CITY OF PINOLE

ADDENDUM 3 **SS-2201 SANITARY SEWER REHABILITATION PROJECT (PHASE 1)** **CIP PROJECT NO. SS-2201**

October 30, 2023

5 HMA SURFACE RESTORATION
- NOT TO SCALE

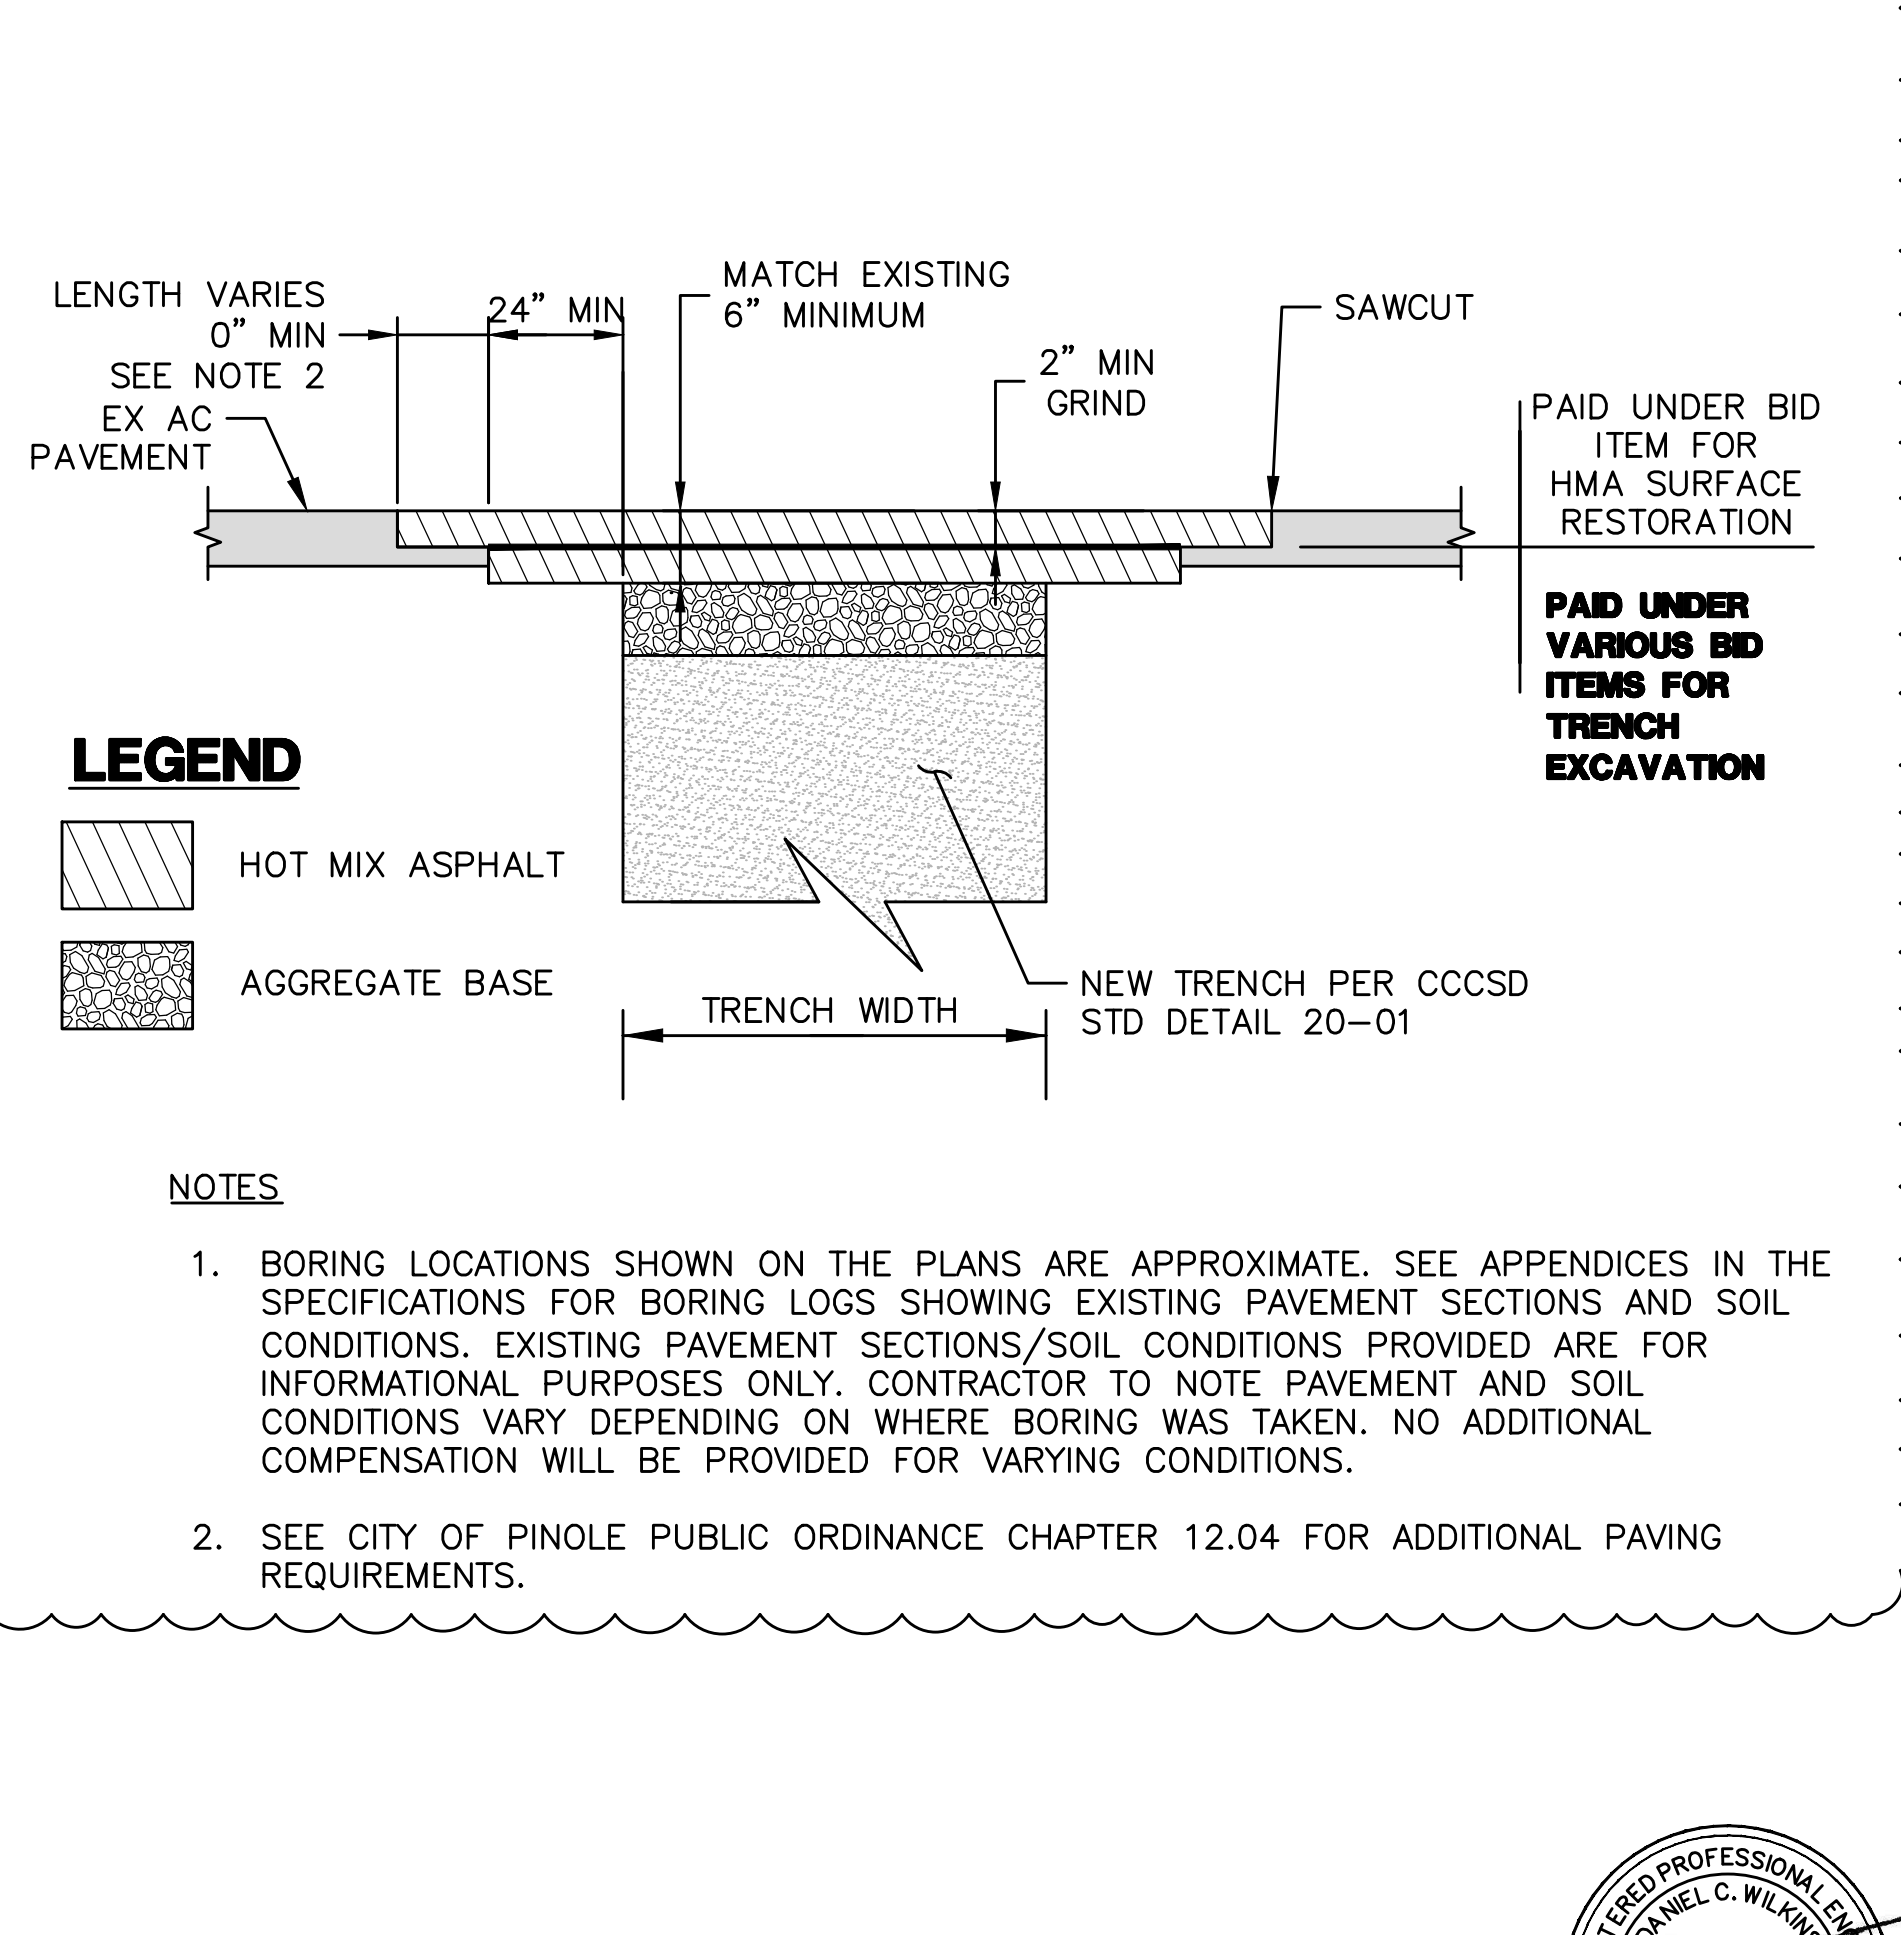
The Contract Unit Price paid for HMA Surface Restoration Including 2” Mill per Detail 5 on sheet D-01 shall be paid per square foot as part of the top 2 inches of surface restoration where directed by the Construction Manager and per Detail 5/D-01. <u>This bid item shall be for the top 2-inches of milling and HMA placed. Payment for HMA placed below the top 2-inches shall be included in various bid items for pipeline work.</u> The prices of installation shall include full compensation for furnishing all labor, materials, tools, equipment and incidentals and for doing all work involved including site clearing/preparation, protecting existing utilities, lowering and raising existing utilities for milling, surveying, sawcutting, 2” mill of existing AC, removal and disposal of existing pavement, dressing sides of existing asphalt with asphalt emulsion, disposal of waste materials, placement and compaction of hot mix asphalt, striping, placement of pavement markers, monument restoration and all other incidentals required to construct the pipe system complete in place as shown on the Plans, as specified and as directed by the Engineer. No adjustment in the contract unit price for HMA Surface Restoration Including 2” Mill per Detail 5 on sheet D-01 shall be made for increases or decreases of more than 25 percent of the quantities set forth in the Schedule of Bid Prices, and provisions of SP-34 “Item Increases and Decreases” shall not apply. |

10/30/23	DCW	REVISED DETAIL 3, ADDED DETAIL 5							
NO.	DATE	BY	DESCRIPTION

Answer: Pavement restoration shall be per the revisions of this Addendum 3. Note, trenches extending into the traveled lane transversely shall be overlaid the entire length of the trench up to the nearest lane line a minimum of 24 inches in both directions from the edge of the trench per the revised Contract Documents. Referenced Chapter 12.04 of the Pinole Municipal Code is available on the City's website under Encroachment Permits at: <https://www.ci.pinole.ca.us/cms/one.aspx?portalId=10947056&pageId=18396737> .
